**Report for London Borough of Brent**  
Kilburn Library, Salusbury Road, London NW6 6NN

Accessibility Audit

05 September 2022

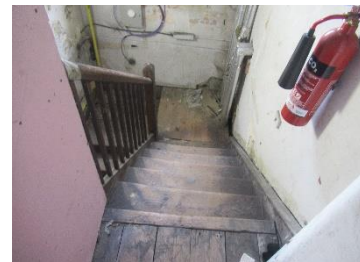
Item	Element	Observations	Recommendations	Cost £	Priority	Photo
1	<b>Externally</b> <b>Parking</b>	There is no vehicular parking provision to the Library.	No action required	n/a	n/a	n/a
2	<b>Approach to building</b> i Main entrance	The main entrance is stepped, measuring 1600mm wide with 3no steps measuring 130mm Risers and 250mm Goings. Nosings are absent from steps. Tactile paving is absent from steps. Guard railings are provided which serve as a hand rail but this does not meet the standard requirements for a handrail.	Fit new non slip nosings where missing.  Lay new tactile paving to base of steps.  Install new nylon coated handrail to steps, both sides.	£375.00  £400.00  £2,000.00	A  C
